CITY OF ALBUQUERQUE

PLANNING DEPARTMENT – Development Review Services

RE: Valle Vista at the Trails, Unit 2 (File: C09D009)
Grading and Drainage Plan, Engineer's Stamp Date 6-23-2014
Revised Grading Plan, (verbally approved) Engineer's Stamp Date 1-20-15
Engineer's Certification Date: 3-18-16

DRAINAGE AND TRANSPORTATION INFORMATION SHEET (REV 09/2015)

**CITY OF ALBUQUERQUE**
PUBLIC WORKS DEPARTMENT
VALLE VISTA UNITS 1, 2 & 3
GRADING AND DRAINAGE PLAN

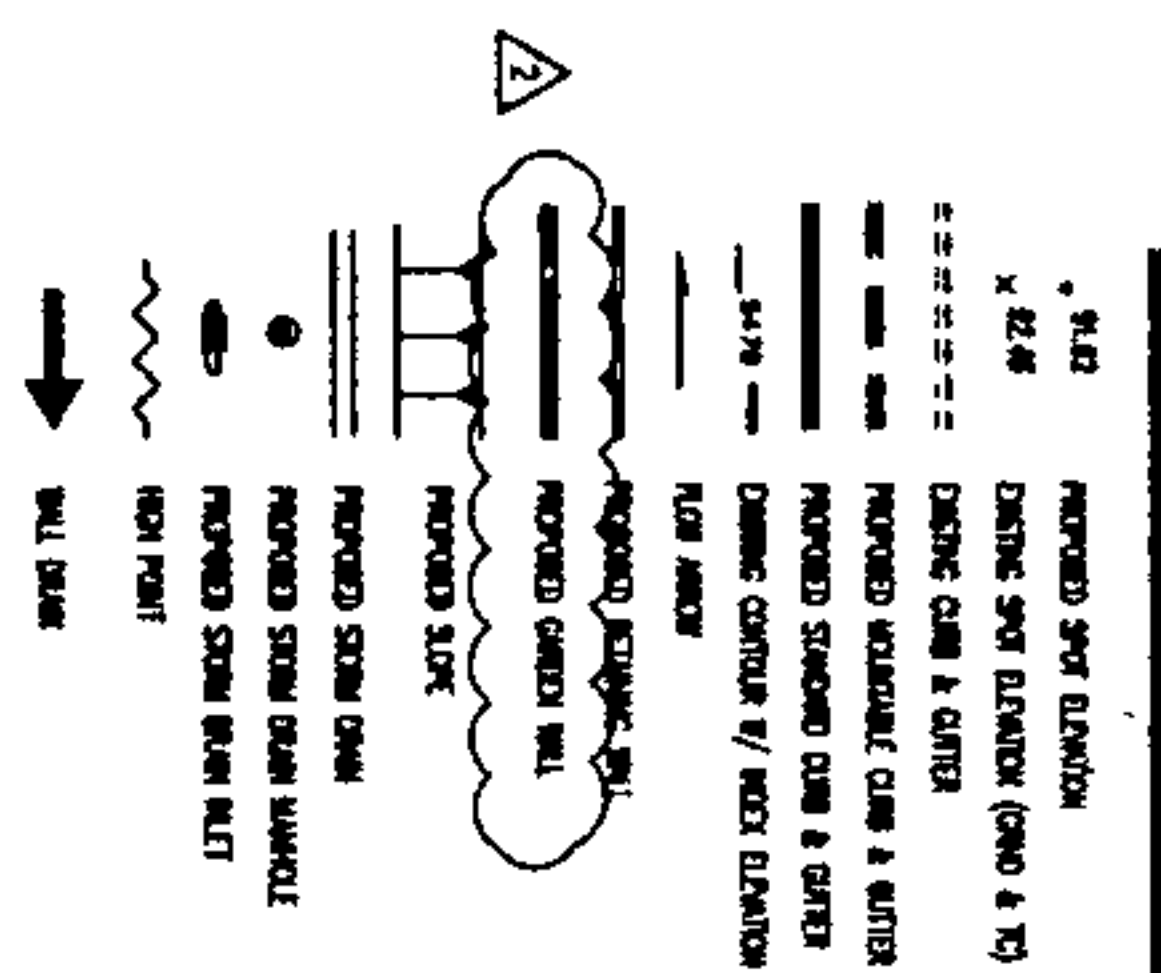
1. Add a note to the certification that the homebuilder is to construct the side yard wall drain on Lot 17. Would you recommend a turn-block?
2. It appears the rear-yard retaining wall is still required on Lot 3 Unit 2. The TW is about 52 and the BW is about 48.
3. It appears the side-yard retaining wall is required between lots 5 and 6/7 maybe 8. TW is high than 40 and the BW is 37 and some change.

As an informational comment. In general Hydrology only requires 4 points for a pad cert: back two corners, top of curb and the pad. However, when there is a side yard retaining wall changes in the pad grade causes changes in the side-yard grade, which may impact whether a retaining wall is required or not. Without the side-yard grades being as-built makes it difficult for Hydrology to review.

For the Lot 3, Unit 2 rear wall, there is some excess dirt that has not been removed, but will be required to be removed in order for the homebuilder to construct the lower garden wall per this plan. The existing dirt slope will be excavated/removed for the lower wall construction and backfilled upon wall completion, and slope constructed from the upper wall along Woodmont and the lower garden wall.

For the Lot 5, Unit 3 side wall adjacent to the Lots 6-8 back wall, a slope will need to be constructed in order to build the wall per the attached plan. This slope will be destroyed and rebuilt with the wall construction to be completed by the homebuilder.

I think seeing the revised plan will help you w/understanding the intent of the design. I will call to discuss.

C09-D001
THE TRAILS Units 1-3
Amended D M P
Drainage Management Plan
April 2014
- Composite of Plates 1 & 2 -

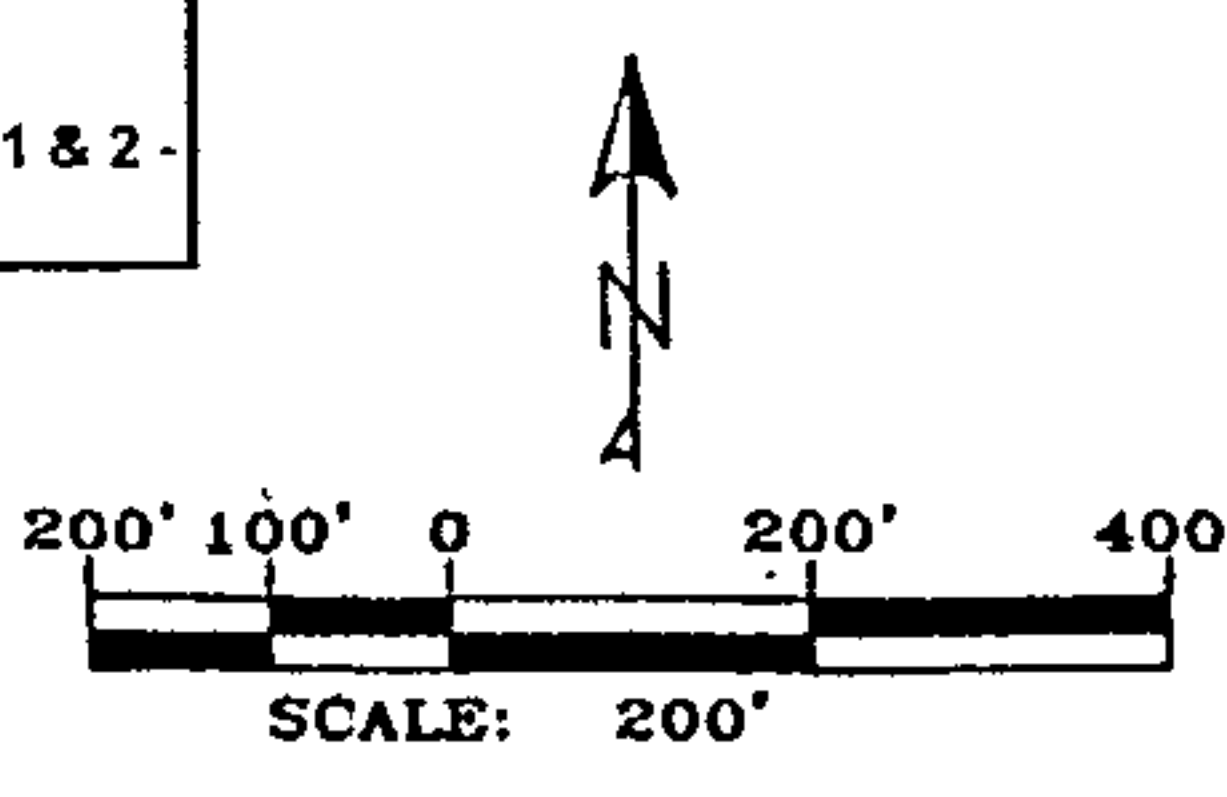
1. Verify pipe diameter of storm drain entering the "D" inlet in Valle Huerto. It's supposed to be a 30", looks like a 24".
2. In the downstream end of the "D" inlet in Valle Jardin, the vertical walls appear to extend down to only leave an opening of 16" or so.
